**NOTICE OF INVITATION OF BID – DESIGN BID BUILD PROJECT
REHABILITATE TAXIWAY 'D', SHOULDERS AND CONNECTORS
Tucson Airport Authority (TAA) Project No. 10113362
FAA AIP No. 3-04-0045-077-2018**

**ADDENDUM No. 2
July 11, 2018**

DEMOLITION PLAN - SCHEDULE III			
DRN:JML	DES: JHA	CK: RWT	DRAWING SHEET
DATE: 04/11/18	DATE: 04/11/18	DATE: 04/30/18	
SCALE: 1" = 40'			CD2.02 105 of 134

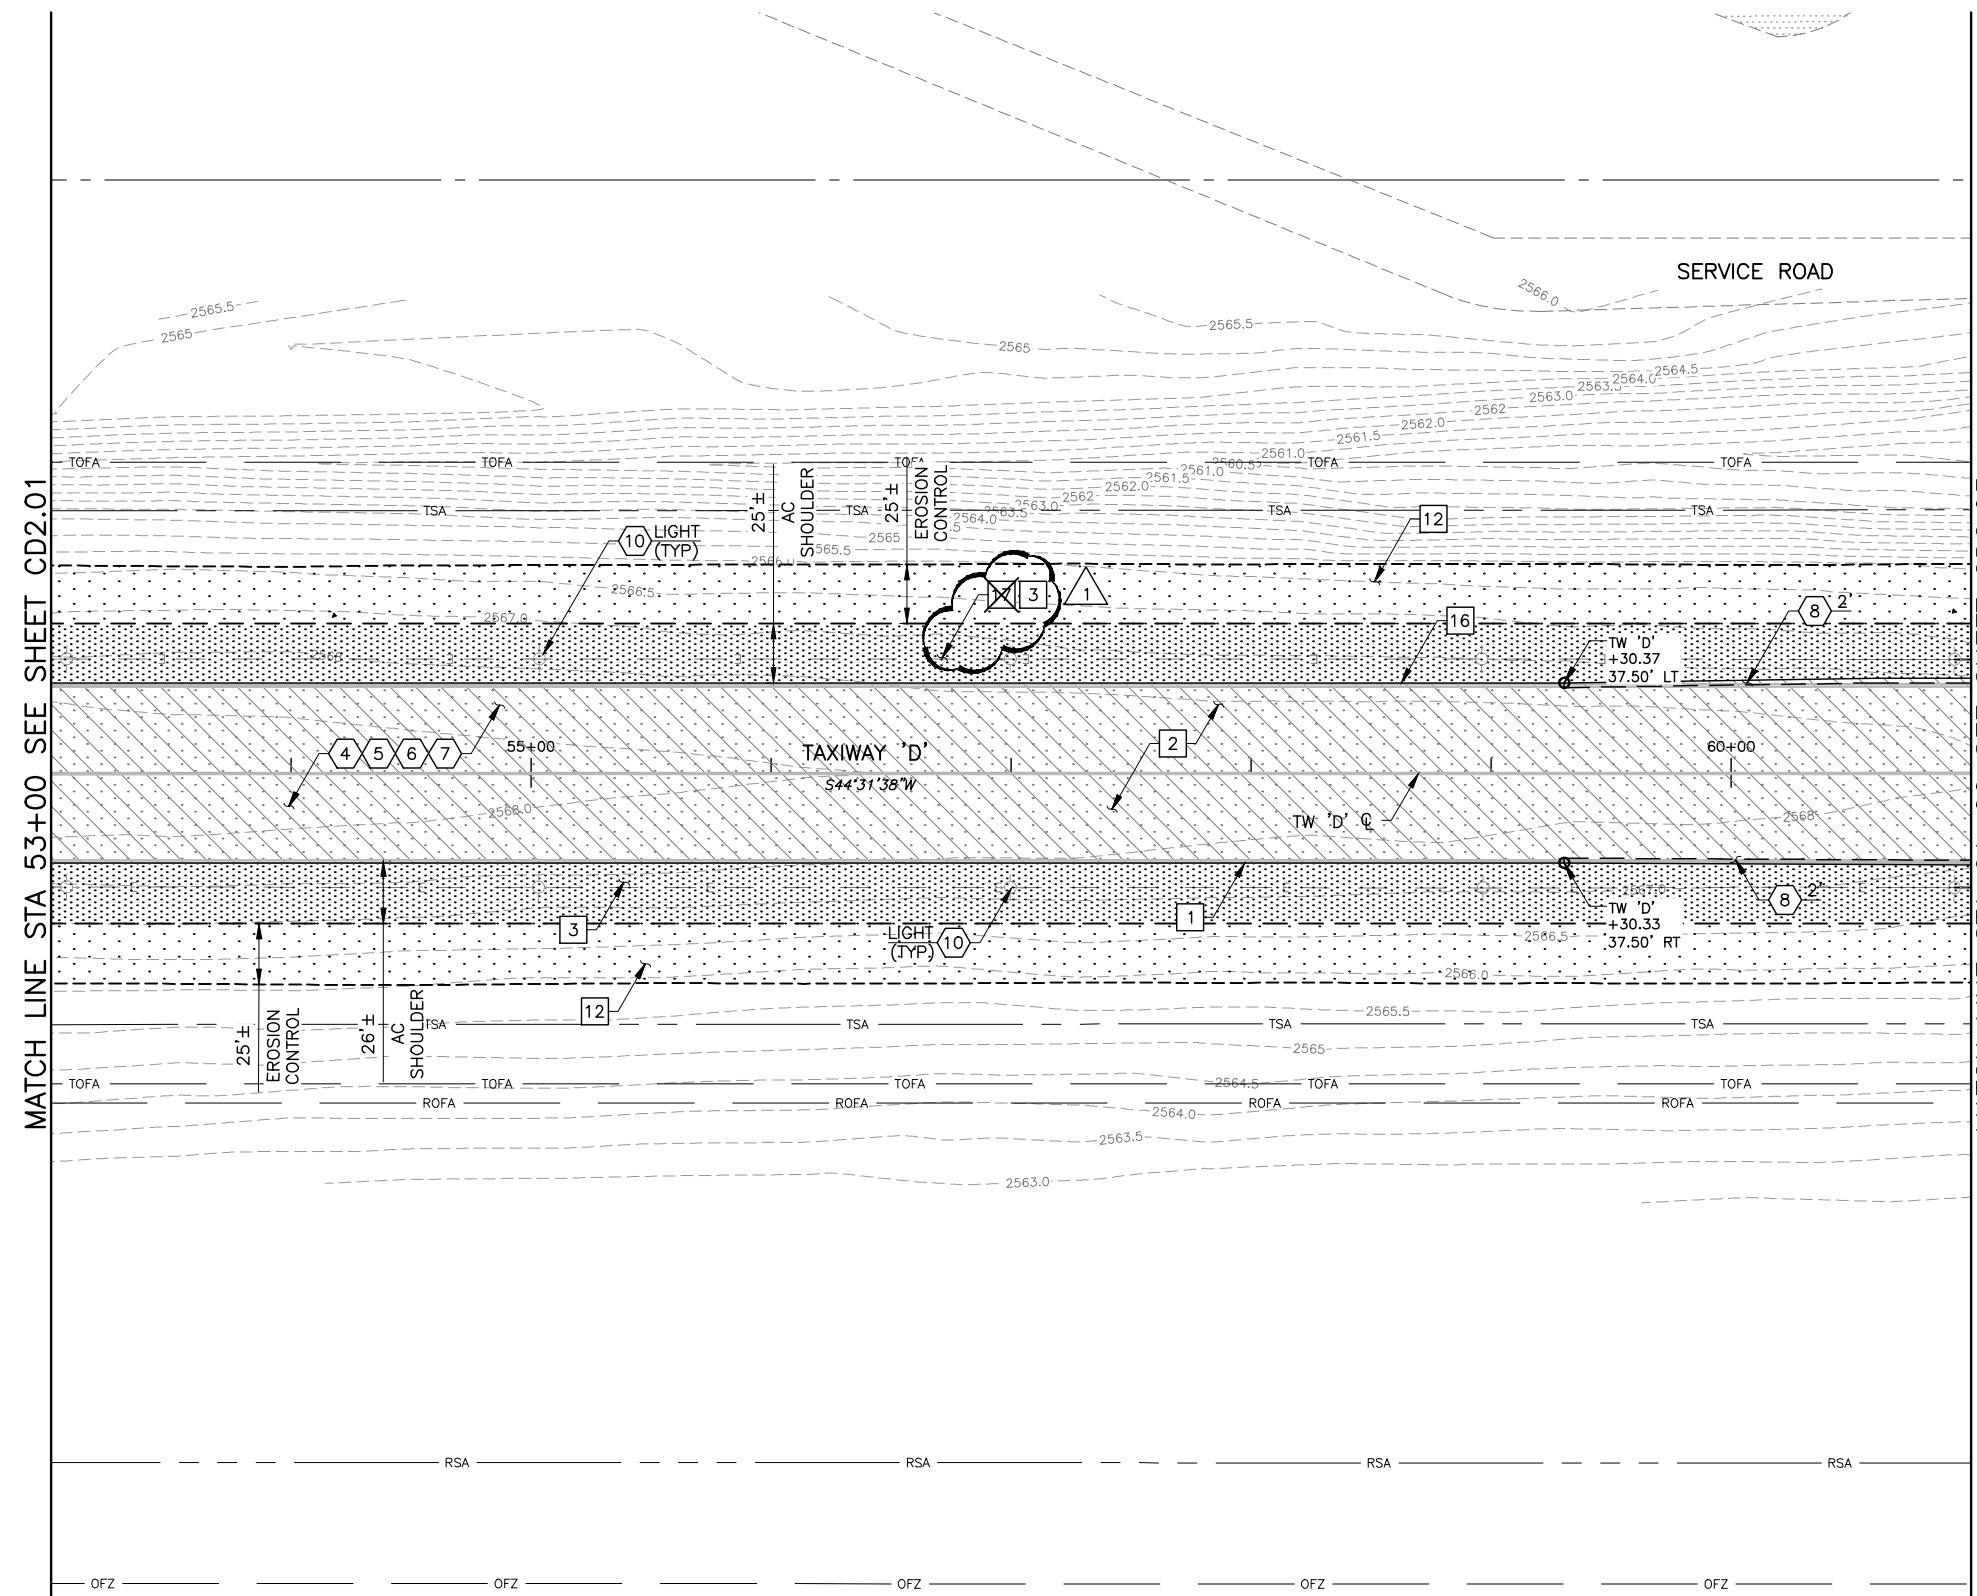
24. **Question:** On sheet 105 the Remove shoulder AC calls out Note 17 on the east shoulder, which is 6.5" depth but has no start and stop stations. Sheet 104 & 106 both call out Note 3 which is Remove Shoulder AC 2"-2.5" Depth. If note 17 on sheet 105 is correct we need to know the limits of the 6.5" removal.

Response: Correction has been made to Sheet 105 denoting Removal Note 3 instead of 17. See attached for corrected Plan Sheet 105 and updated Bid Schedules correcting the quantity of this item, and deleting the reference to Removal Note 17.
